<b>NOTICE OF REVISION (NOR)</b>		1. DATE (YYMMDD) 98-03-13	Form Approved OMB No. 0704-0188
THIS REVISION DESCRIBED BELOW HAS BEEN AUTHORIZED FOR THE DOCUMENT LISTED.			
Public reporting burden for this collection is estimated to average 2 hours per response, including the time for reviewing instructions, searching existing data sources, gathering and maintaining the data needed, and completing and reviewing the collection of information. Send comments regarding this burden estimate or any other aspect of this collection of information, including suggestions for reducing this burden, to Department of Defense, Washington Headquarters Services, Directorate for Information Operations and Reports, 1215 Jefferson Davis Highway, Suite 1204, Arlington, VA 22202-4302, and to the Office of Management and Budget, Paperwork Reduction Project (0704-0188), Washington, DC 20503. PLEASE DO NOT RETURN YOUR COMPLETED FORM TO EITHER OF THESE ADDRESSES. RETURN COMPLETED FORM TO THE GOVERNMENT ISSUING CONTRACTING OFFICER FOR THE CONTRACT/ PROCURING ACTIVITY NUMBER LISTED IN ITEM 2 OF THIS FORM.		2. PROCURING ACTIVITY NO.

3. DODAAC	
4. ORIGINATOR	b. ADDRESS (Street, City, State, Zip Code) Defense Suppl

FIGURE A-1

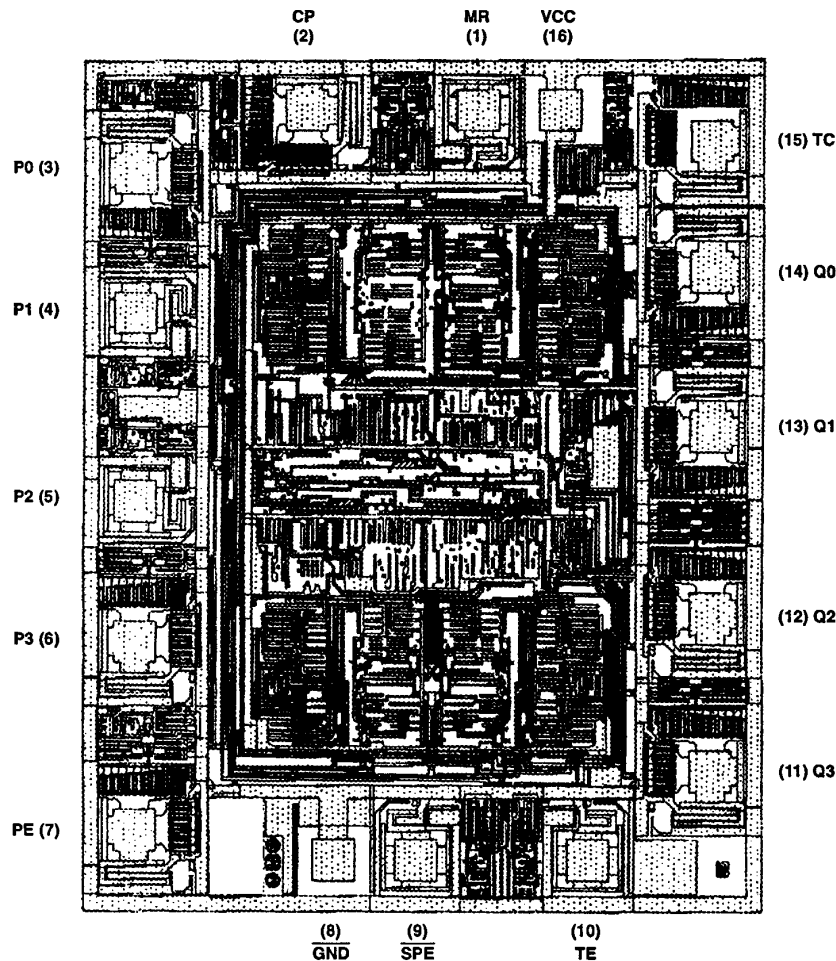
Die Size: 2190 x 2650 microns.  
 Die Thickness: 21 +/-2 mils.

The following metallization diagram supplies the locations and electrical functions of the bonding pads. The internal metallization layout and alphanumeric information contained within this diagram may or may not represent the actual circuit defined by this SMD.

Top Metallization: SiAl 11.0kA +/- 1kA  
Backside Metallization None  
Glassivation  
Type: SiO2  
Thickness 13.0kA +/- 2.6kA  
Substrate: Silicon on Sapphire (SOS)

Substrate Potential: Insulator  
Special assembly instructions: Bond pad #16 (VCC) first.
